SURRY POWER STATION
ORGANIZATION CHART

DISCUSSION OF PROPOSED TECHNICAL SPECIFICATION CHANGE

OFFSITE ORGANIZATION FOR
FACILITY MANAGEMENT AND TECHNICAL SUPPORT

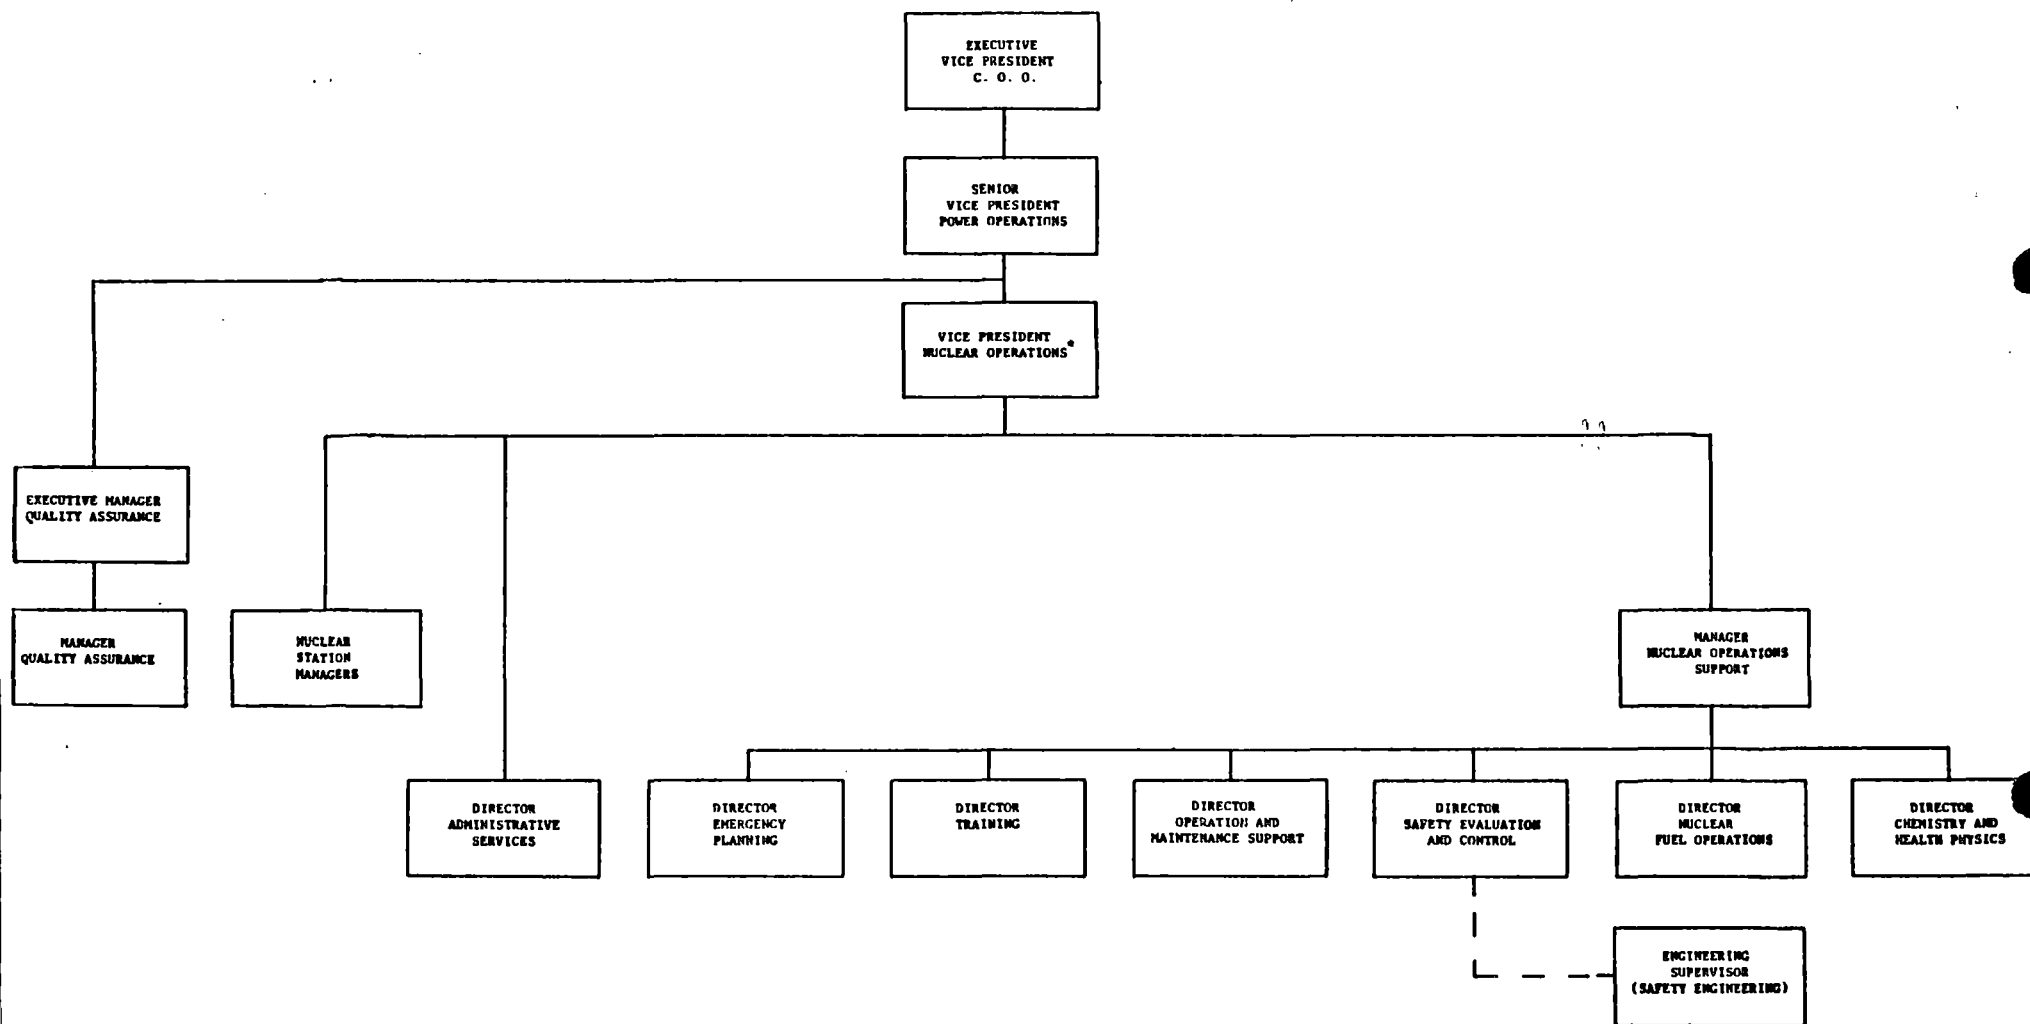
This proposed Technical Specifications change reflects the recent reorganization within the Nuclear Operations Department. This reorganization deletes the position of Manager, Nuclear Operations and Maintenance and renames the Manager, Nuclear Technical Services to the Manager, Nuclear Operations Support. The Manager, Nuclear Operations Support will carry out his old responsibilities plus assume the responsibilities of the Manager, Nuclear Operations and Maintenance. The new responsibilities that transfer to the Manager, Nuclear Operations Support are Emergency Planning, Training and Operations and Maintenance Support. In addition, the Nuclear Fuel Operations group is a new responsibility that is added to the Manager, Nuclear Operations Support. Technical Analysis and Control has been deleted from the responsibilities of the Manager, Nuclear Operations Support. The Director, Administrative Services will report directly to the Vice President-Nuclear Operations. This reorganization maintains the direct communications between the Vice President-Nuclear Operations and the Nuclear Power Station Managers. Also the title of the Executive Vice President has been changed to the Executive Vice President and Chief Operating Officer.

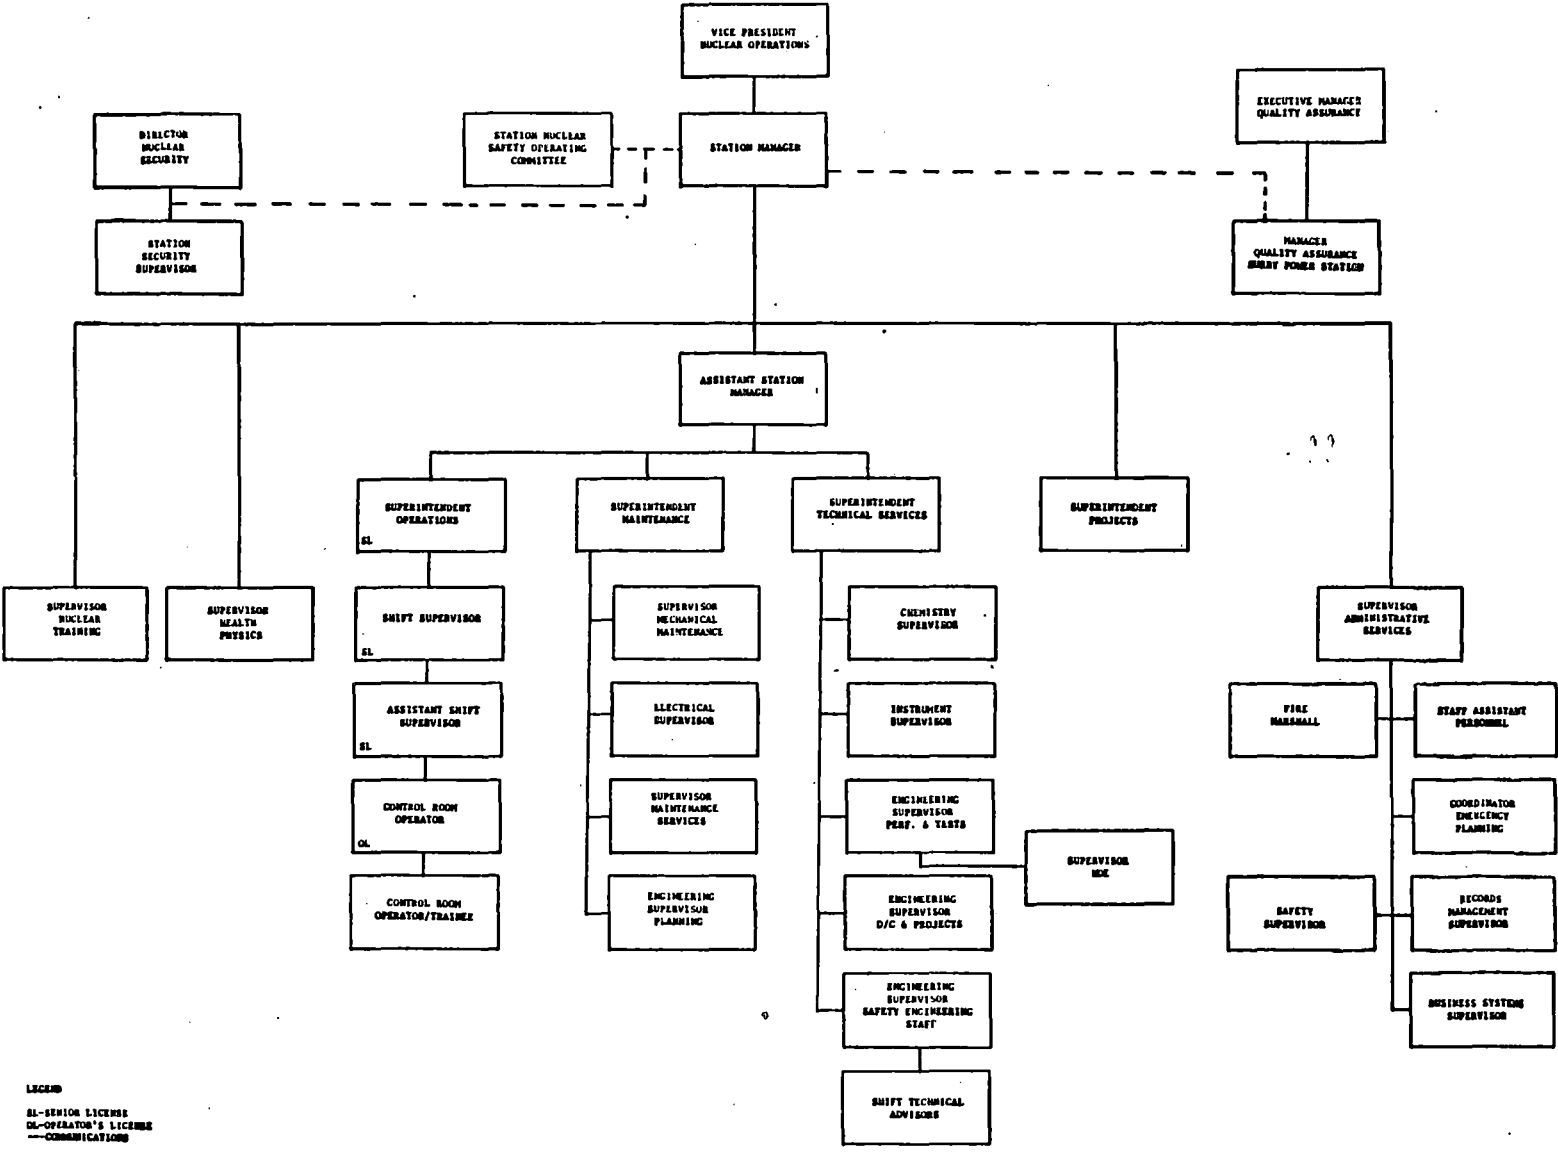
This Technical Specifications change also reflects the recent reorganization of the Security Department. The proposed change has the Station Security Supervisor reporting to the Director, Nuclear Security at the corporate office. The Station Security Supervisor will continue to have communications with the Supervisor Administrative Services at the station.
